Detailed Site Plan

Penn Logistic Center

DSP-23013

STAFF REPORT

Figure 1: Cross-Section of the Street frontage of Marlboro Pike

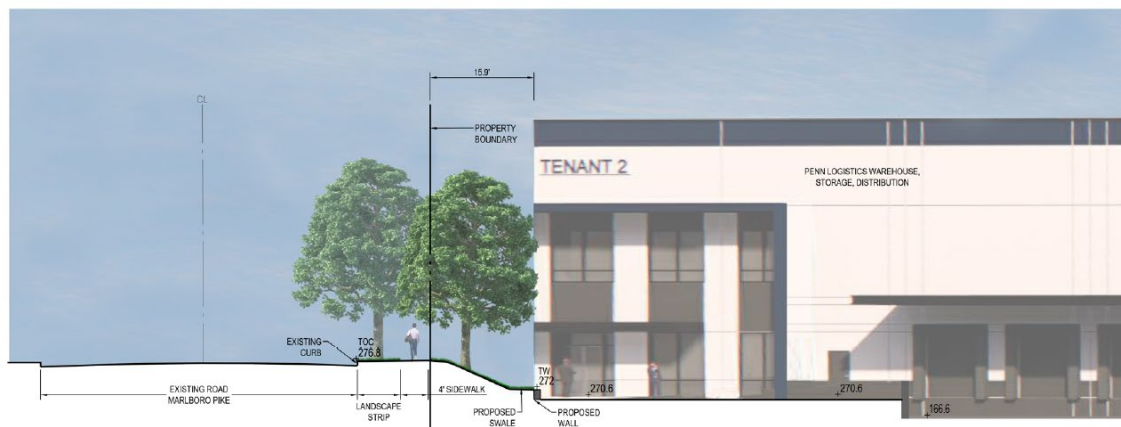
Due to existing site constraints, there is a significant difference in grade, between the Marlboro Pike elevation and the first-floor elevation of the proposed building (and the subject property). Subsequently, access to the office will be located on the west side of the building because locating the office entrance on Marlboro Pike is unfeasible. The applicant proposes to include benches and bike racks by the office entrance.

Figure 2: North Elevation along Marlboro Pike

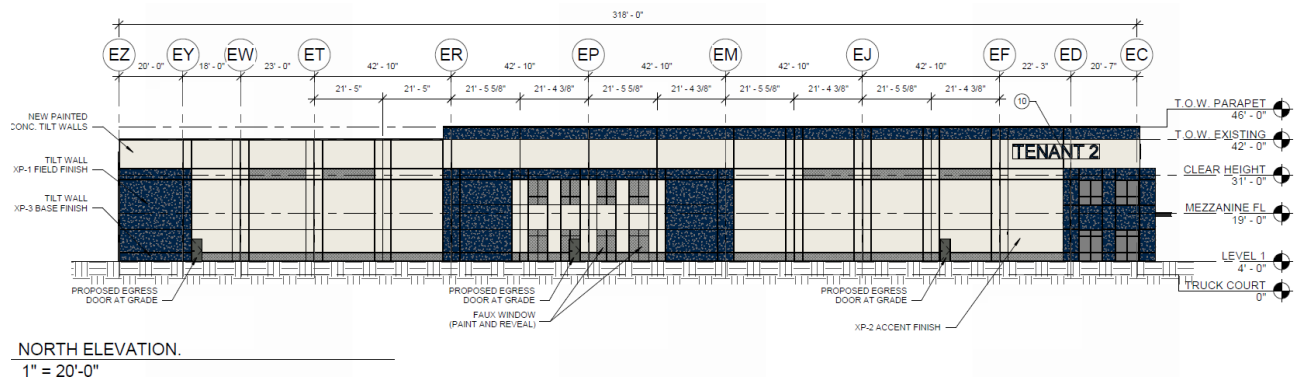
The architectural design of the existing portion of the building and the proposed addition is a typical, contemporary industrial building, with a flat roof. For the former, the applicant proposes to repair and repaint its façades and install new metal coping on the edge of its parapet walls, making it compatible with the new addition. The new addition consists of four different painted, concrete, tilt panels. To avoid the north elevation being a blank wall fronting Marlboro Pike, the applicant designed this elevation with faux windows and accent panels using reveal and paint to mimic the main entrance of the office, located at the northwestern corner.
